STATE OF WASHINGTON
DEPARTMENT OF ECOLOGY

Re: Constituent, Vinson Latimore, Case Number 573173

- **Property Address:** 10816 18th Avenue East, Tacoma, Pierce County, WA
- **Site Name:** Gibraltar Senior Living
- **Cleanup Site No.:** 12686
- **Facility/Site No.:** 6607
- **VCP Project No.:** SW1472

Re: Further Action at the following Site:

Exhibit 2 from Terracon's Supplemental Limited Site Investigation report, dated November 6, 2015.

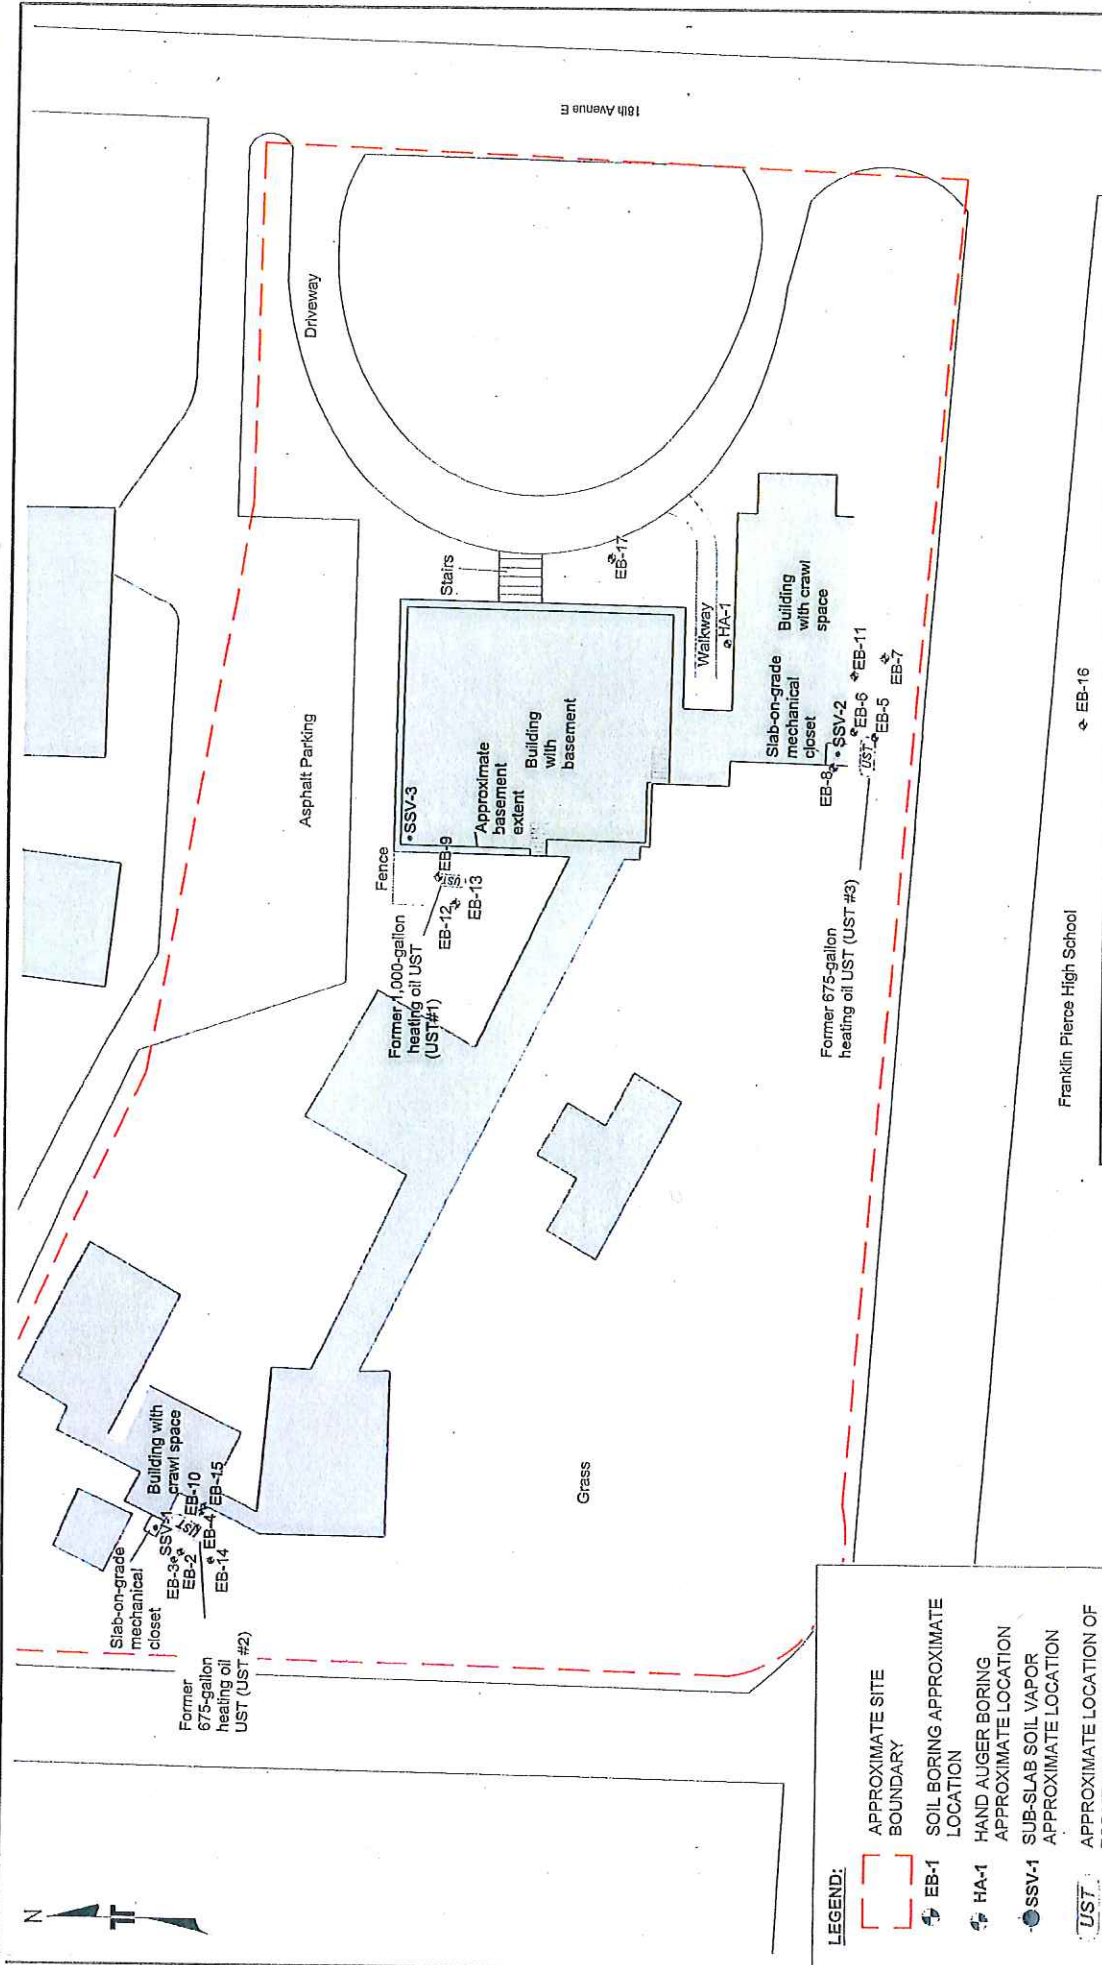
In summary, Ecology remains concerned that contamination associated with the SW1472 Site is not delineated in a manner compliant with MTCA. Based on the February 1, 2018, letter submitted by Mr. Latimore's attorney, he disagrees with Ecology's recommendations regarding boring EB-16. Ecology is in the process of finalizing an opinion letter in response to Mr. Latimore's attorney's February 1, 2018, letter.

EXHIBIT
1

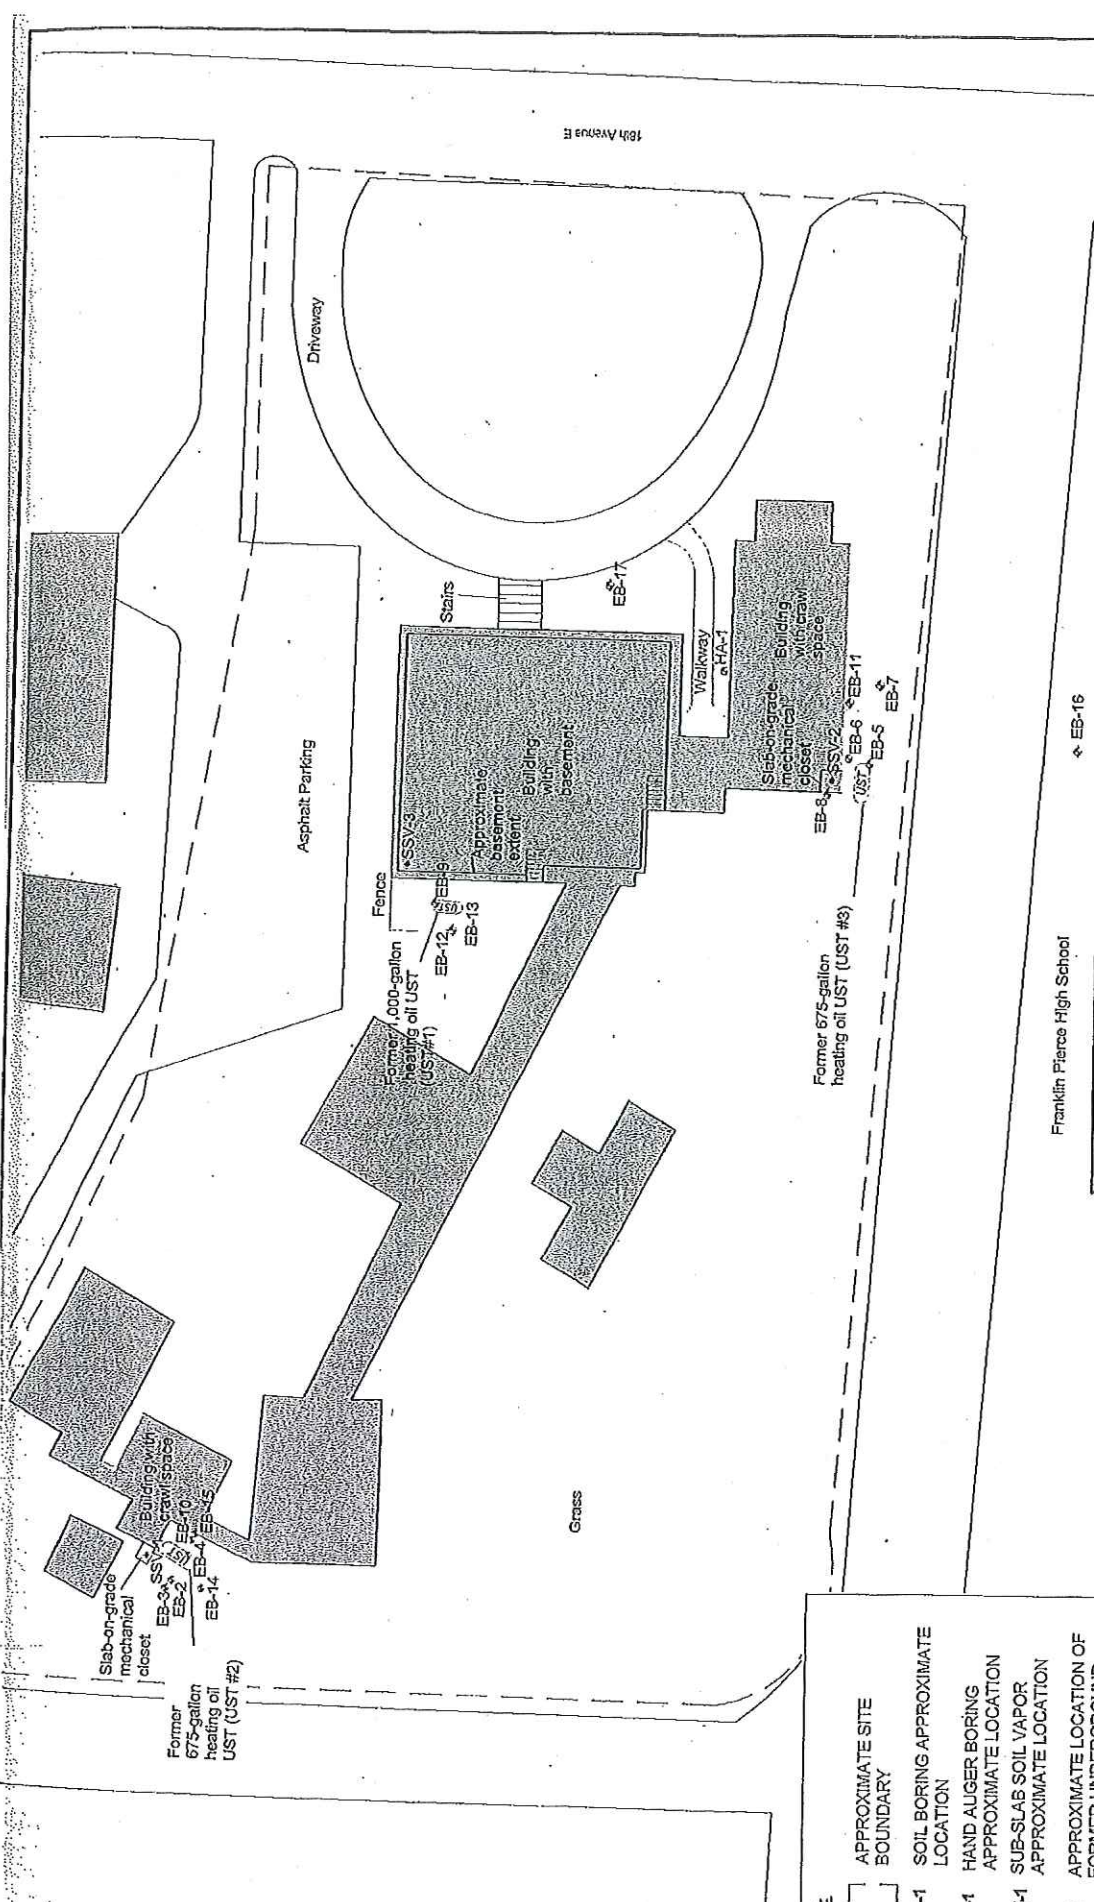
- The Tier I Sub-Slab Soil Vapor sampling results exhibited detections of naphthalene and chloroform exceeding both the screening and cleanup levels. Chloroform was detected in soil vapor sample SSV-2 (in the vicinity of UST#3/southernmost out building) and naphthalene in SSV-1 (in the vicinity of UST#2/northernmost out building). Concentrations for chloroform and naphthalene were 70.1 micrograms per cubic meter ($\mu\text{g/m}^3$) and 39.9 $\mu\text{g/m}^3$, respectively (Figures 1, 3, & 4).

- Groundwater collected from the off-Site temporary well point (EB-16) exhibited detections of TPH-Dx (690 $\mu\text{g/L}$) and TPH-HO (1,300 $\mu\text{g/L}$). Groundwater collected on-Site from EB-8 (located in close proximity to UST#3) and EB-13, & 14, all exhibited TPH detections below the respective MTCA Method A CULs or laboratory PQLs.

1. Ecology requests further vapor assessment and sampling of air within the on-Site crawl spaces associated with the two smaller, single-story structures. Terracon collected sub-slab soil vapor samples at SSV-1 & SSV-2, where naphthalene and chloroform vapor concentrations exceeded the applicable screening levels and/or reporting limits. Please analyze air samples utilizing EPA Method TO-15, and

SITE DIAGRAM UST #3

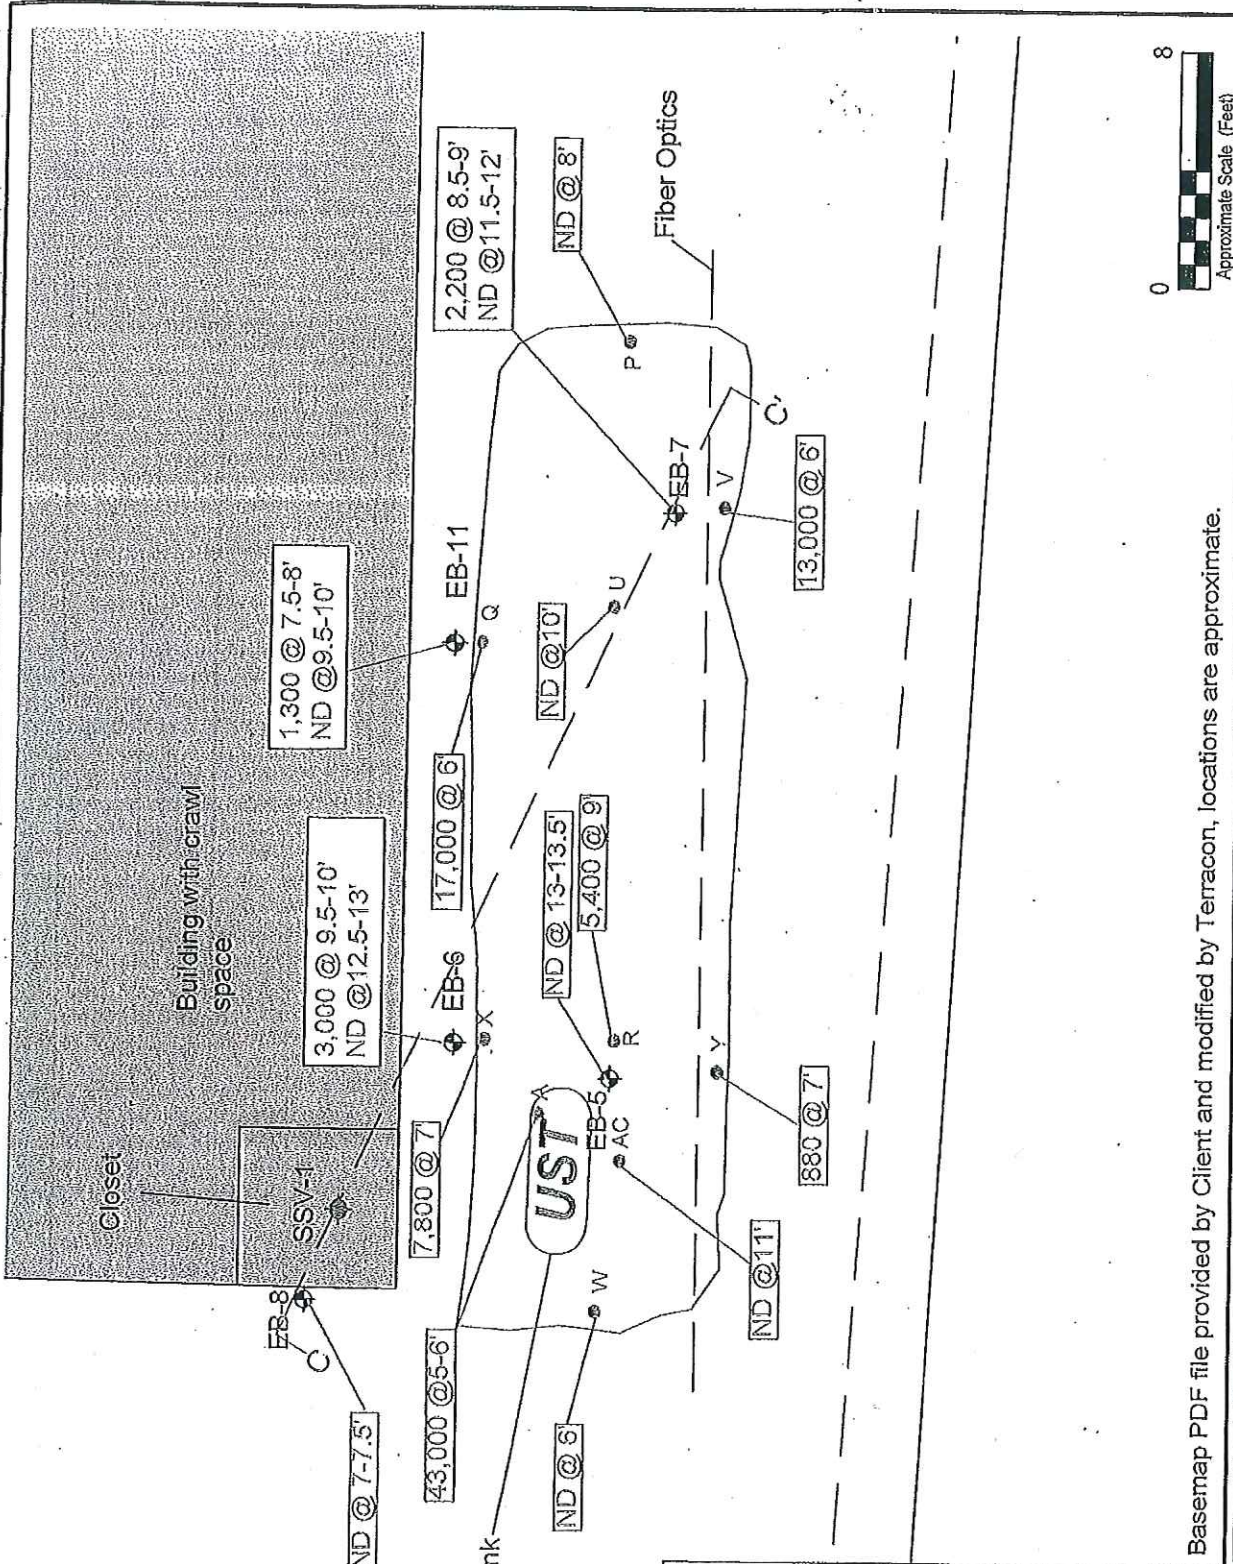
- UST #3: Terracon collected eight soil samples and one groundwater sample. Soil sample analytical results exhibited TPH-Dx concentrations between 1,300 to 3,000 milligrams per kilogram (mg/Kg). The groundwater analytical result exhibited a concentration of 55 $\mu\text{g/L}$.

Figure 1

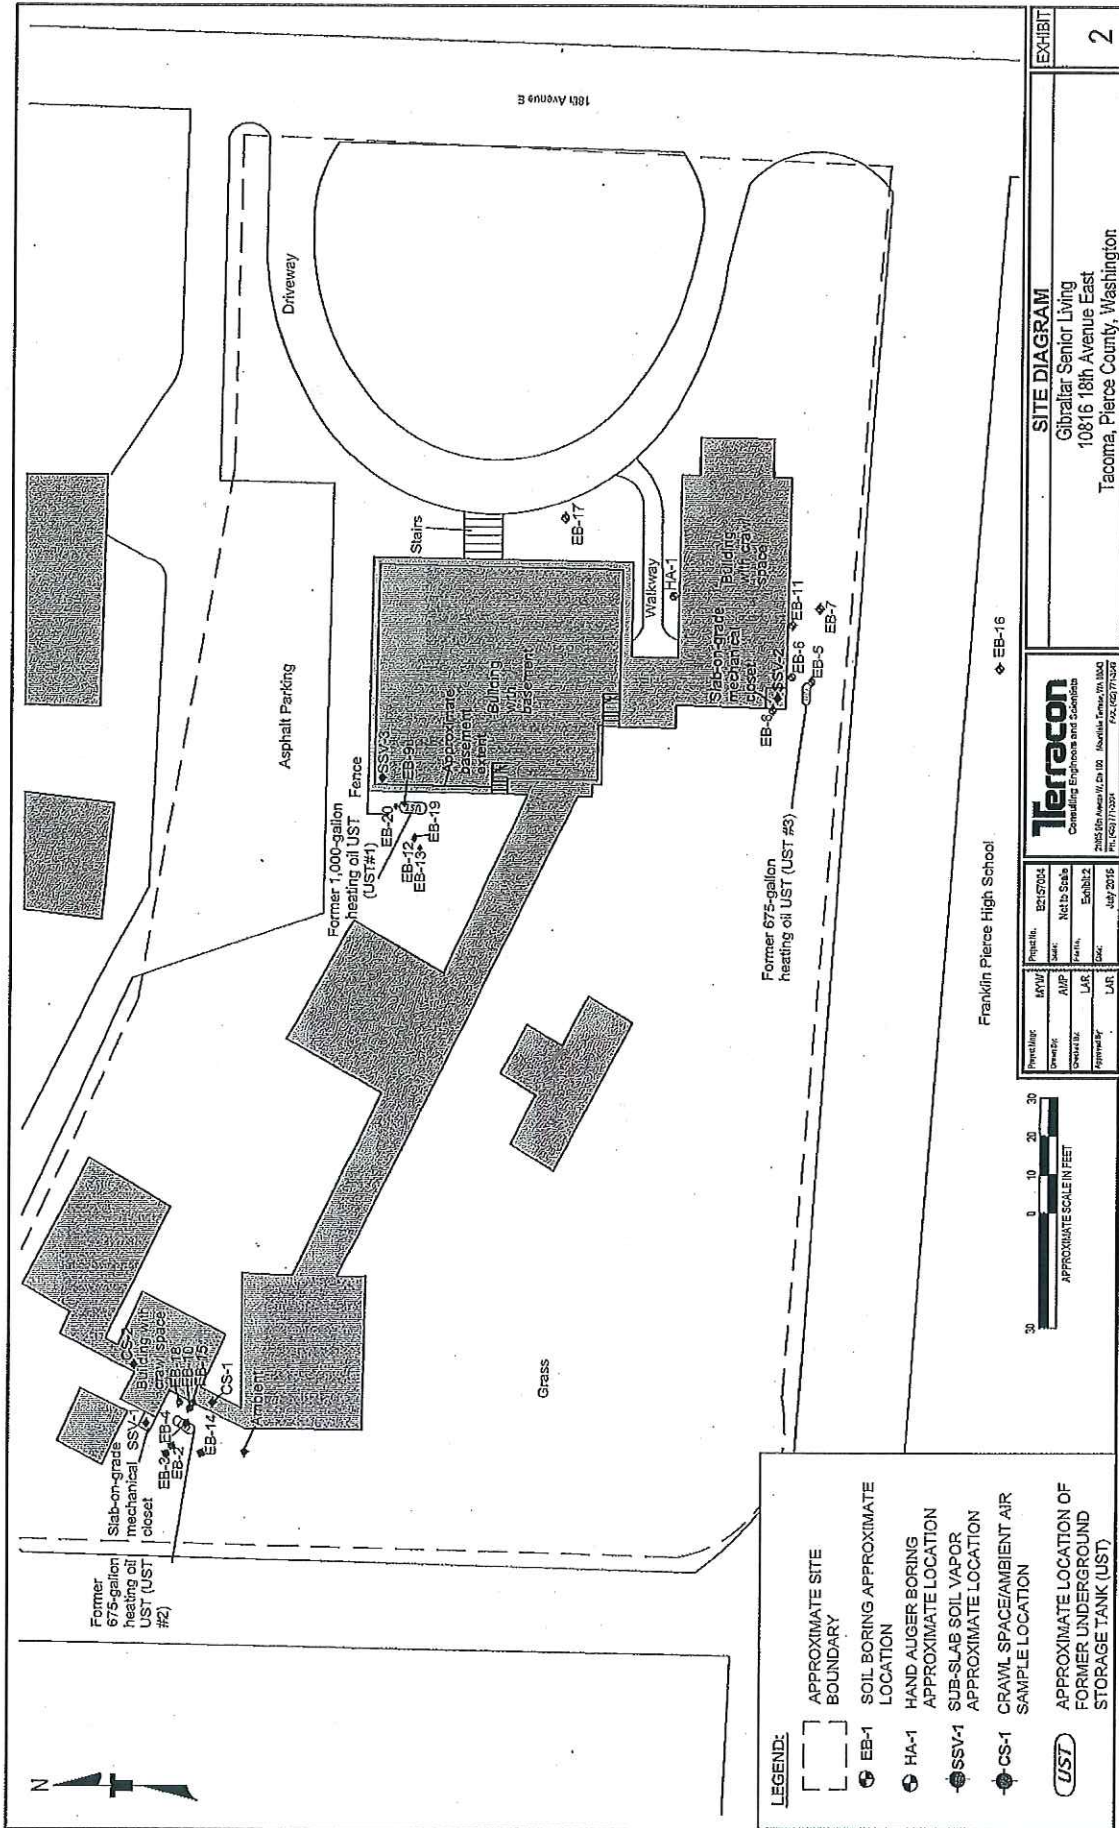
- This memorandum limits discussion of Site contamination to the off-Property diesel and heavy oil concentrations in groundwater collected from boring EB-16 (Figure 1).

northwest of EB-16. Based on the distance and discontinuous nature of the perched groundwater in the vicinity, this off-site release is not anticipated to be the source of the oil-range TPH detection at EB-16.

The second off-site facility, the Franklin High School site, is the location of a release associated with two former heating oil USTs, located approximately 475 feet southwest of EB-16. Based on the distance and discontinuous nature of the perched groundwater in the vicinity, this off-site release is also not anticipated to be the source of the oil-range TPH detection at EB-16."

- 2) The laboratory's comment on the chromatogram for EB-16 included in Terracon's *Supplemental Limited Site Investigation* states "unidentified diesel range product (biased high due to motor oil range produce overlap)."

- 3) The ALS chromatogram for EB-16 appears to show both diesel and heavy oil ranges. A line is provided on the chromatogram which seems to separate the diesel and heavy oil petroleum hydrocarbon ranges.

- 7) The type of heavy oil has not been determined.
- 8) No additional analyses have been completed in groundwater (e.g., cPAHs or PCBs) which would inform at EB-16 whether or not the petroleum hydrocarbons in groundwater are diesel range, heavy oil range, or both.

- b. Ecology recommends installing a second monitoring well at former grab groundwater sample location EB-16.
 - c. Ecology suggests installing a third monitoring well in the vicinity of UST #2 in order to calculate a groundwater gradient for the Site and potentially for the purposes of long term groundwater monitoring under any potential environmental covenant at the Site.
